No. 0667-241, Rev. I ATA Code 73-00

SUBJECT: POWER PLANT - REPLACEMENT OF THE CARBURETOR AND MODIFICATION OF

THE CARBURETOR AIR BOX

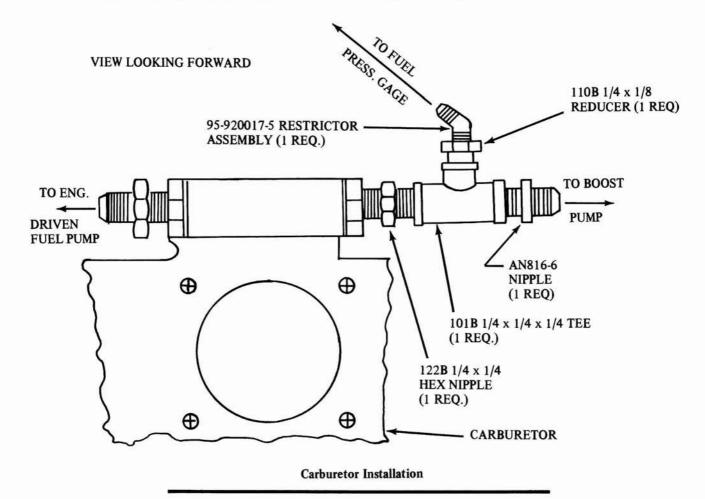
- 1. Remove the upper engine cowling.
- Disconnect all lines, controls and ducts from the carburetor.
- Remove the existing carburetor and install the new carburetor.
- Install the tee, nipples, reducer and restrictor assembly as shown in the illustration.
- Reconnect all lines, controls and ducts to the new carburetor.
  - 6. Inspect the mixture control to ensure full travel.
- Adjust the idle mixture, idle speed and inspect all fittings for possible leaks.
  - 8. Reinstall the upper cowling.
